PREPARED FOR THE PLAN COMMISSION

Project Address: 2501-2525 University Avenue (District 5 – Ald. Bidar-Sielaff)

Application Type: Demolition Permit and Conditional Use

Prepared By: Kevin Firchow, AICP, Planning Division
Report Includes Comments from other City Agencies, as noted

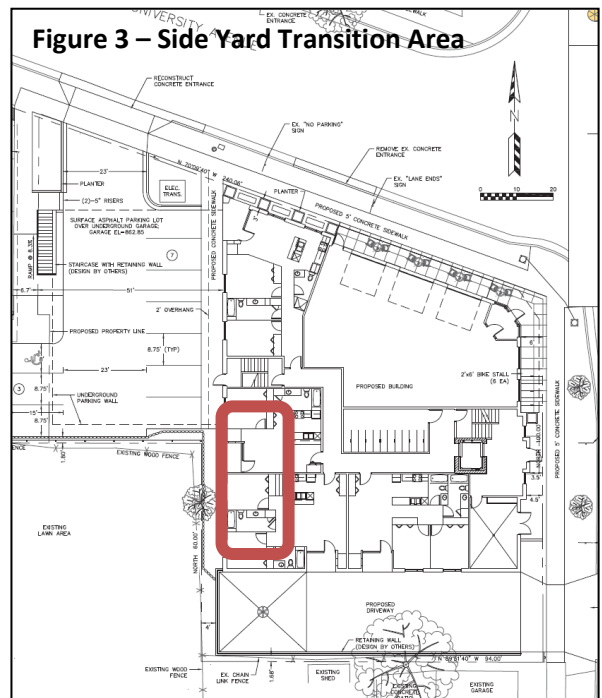
The request to exceed the side/rear yard height transition should also be carefully considered. The area in question is identified in Figure 3. Without conditional use approval, the third floor of the building in this location would need to be "stepped back" at a 45-degree angle above the second floor, as shown by the below zoning code graphic:

In pre-application discussions with the project architect, meeting this standard would result in the reconfiguration of third floor units and the loss of units/bedrooms, which was a significant concern for the development team.

The single-family home at 2510 Kendall Avenue abuts this side lot line. From a grading perspective, that property generally sits between 1-4 feet higher than the proposed subject site, in this area. At the time of report writing, staff has not received any correspondence from that property owner, or other property owners regarding concerns on the proposed setback and stepback.
